Official Transcript of Proceedings
NUCLEAR REGULATORY COMMISSION

Title: ACRS 716TH MEETING

Date: 06-05-2024

Staff Review of NATD-FQL-PLAN-0004, “Fuel and Control Assembly Qualification”

Topical Report Figure 1, “PDC Development Flowchart”

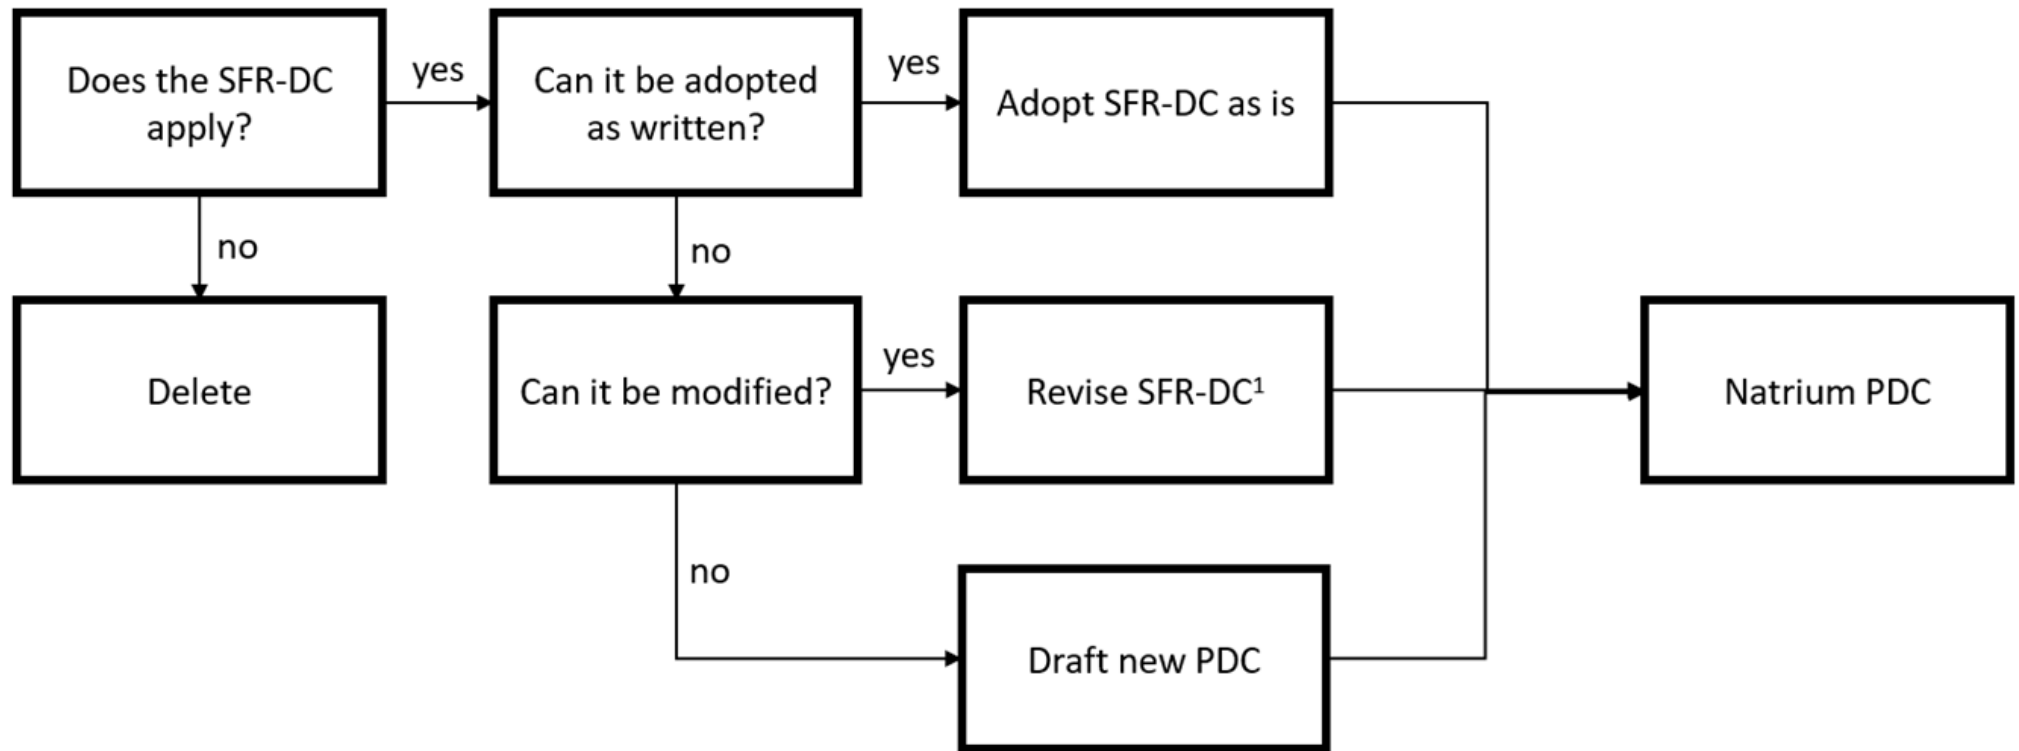
1 MEMBER ROBERTS: I have a similar
2 question, is the topical report doesn't have those
3 bottom two boxes. And there is a limitation in
4 condition in the safety evaluation that does tie to
5 that a little bit. It says that the NRC acceptance is
6 based on an understanding you are using LMP process,
7 so that pretty well drives what you just said.

8 Is there an intent to change the topical
9 report or is the reference from the SCR considered to
10 be sufficient to ensure that a future user does what
11 you just said and not what the topical report says?

12 Let me pull this up. It has this figure
13 without those bottom two boxes. And there's no
14 discussion, at least that I recall, in the report
15 itself of that LMP iteration.

24 I think the intention of the figure in the
25 topical report is to show how the PDC were developed
